**RE: Lobo Crossing – TIA – 1st Review
L15D051, City of Albuquerque**

Bowman is in receipt of the New Mexico Department of Transportation's review comment letter (dated August 6, 2025) for the proposed Lobo Crossing TIA in the City of Albuquerque, NM. In order to facilitate the review, the Department's comments are in italic text and our responses are in normal text.

In the summary page vii

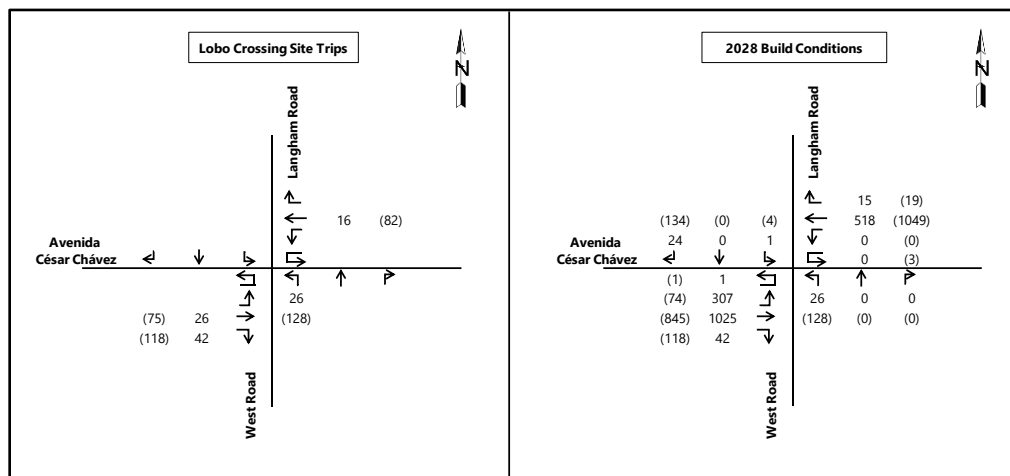
Two signals are to be installed at the intersections of Gibson Blvd. with Alumni Drive and at University Blvd with the Full Access Driveway/Albuquerque Housing Authority since signal warrants are met.

The peak hour warrant is met at the intersection of Avenida Cesar Chavez/West Road/Langham Road (3 of 6 hours Met) and the developer does not plan on putting a signal. The report shall show the volume and percent added traffic volume at the intersection and determine a proportional share for the signal installation by the developer.

Response: The Applicant has agreed to offer a “fair share” contribution towards the installation of a traffic signal at the intersection of Avenida Cesar Chavez/West Road/Langham Road. The proposed “fair share” methodology was developed based on the projected percentage of the Lobo Crossing’s site traffic on this intersection under Future 2028 Build Conditions.

The fair share calculation developed with this methodology is as follows:

- All Approaches
 - 513 Site Trips / 4,334 Total Peak Hour Trips = 12%

As shown above, the traffic volume projections at the intersection indicate that a fair share contribution of **12%** should be provided by the Applicant towards the installation of a traffic signal at the intersection.
